UNITED STATES ENVIRONMENTAL PROTECTION AGENCY
REGION 6
1445 ROSS AVENUE, SUITE 1200
DALLAS, TX 75202-2733

February 20, 1996

ENCLOSURE NO. 1
EPA RESPONSE TO SPARTON'S COMMENTS OF NOVEMBER 6, 1995

Proposed Critical Management Areas in the Albuquerque Area

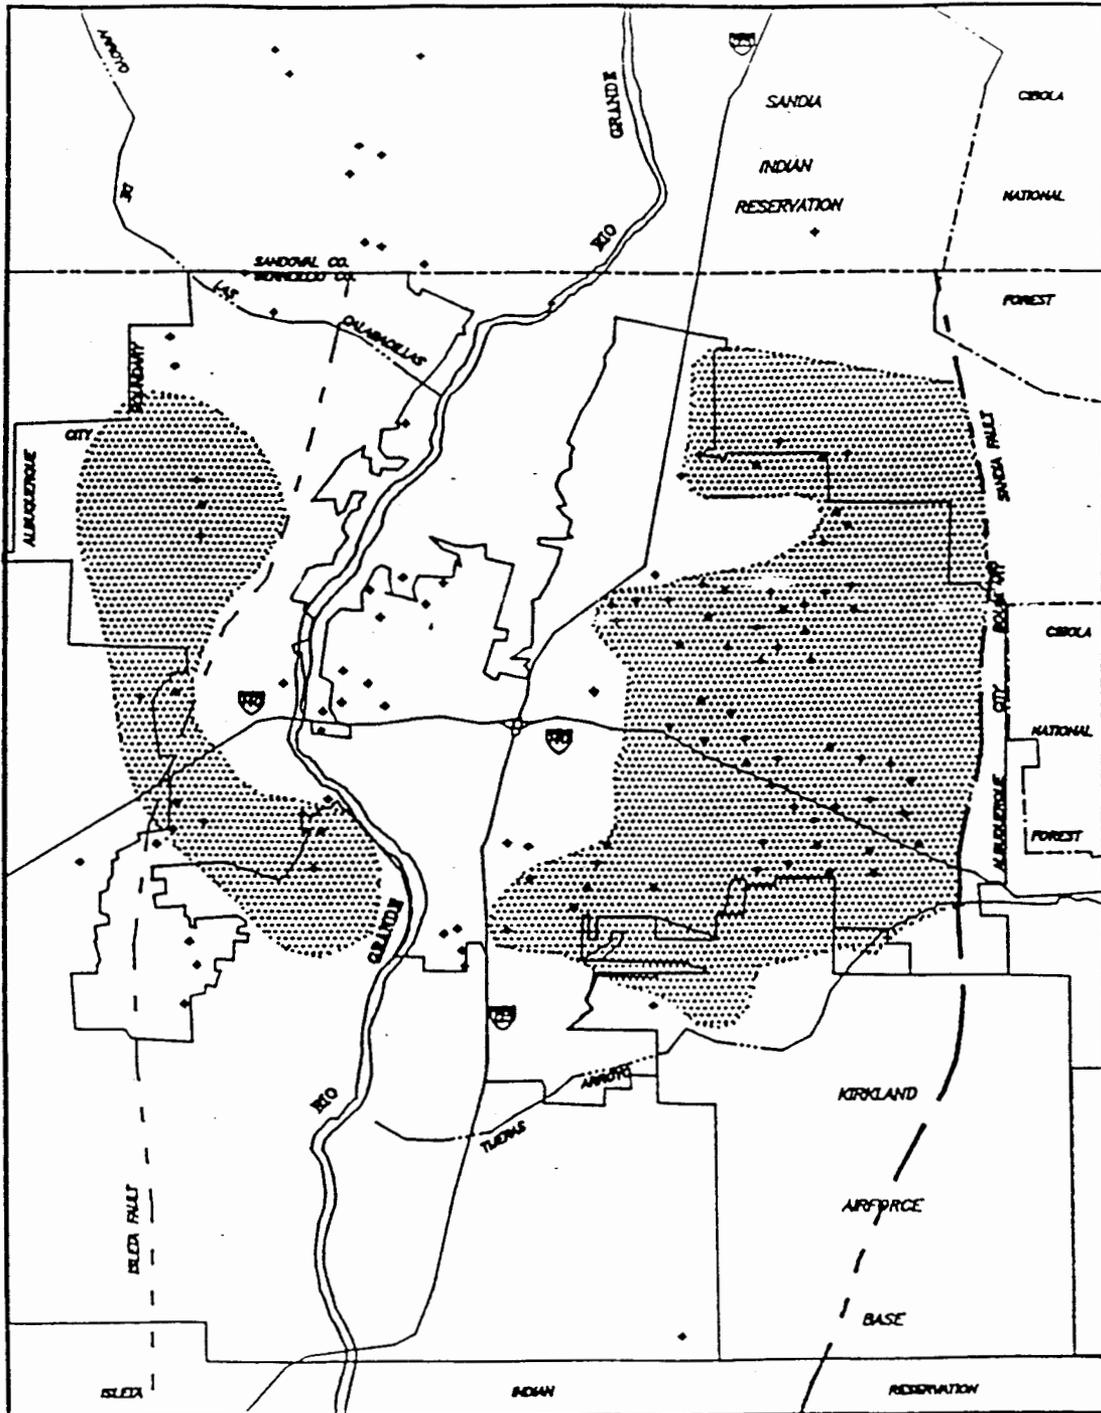
Sparton has provided numerous statements in an attempt to justify why the aquifer will not be utilized for drinking water in the area of the Sparton plume. Specifically, Sparton contends that the Critical Management Areas (CMAs) proposed by the State Engineers

Office (SEO) would prevent well development west of the Rio Grande and in the area of the Sparton Coors Road facility. However, the Sparton Coors Road facility and contaminant plume is located northeast of the CMA proposed for the area west of the Rio Grande (see Figure 1 attached to the City of Albuquerque letter dated December 5, 1995). Therefore, there is no obvious restriction from the proposed CMA on future well development in the area of the Sparton facility.
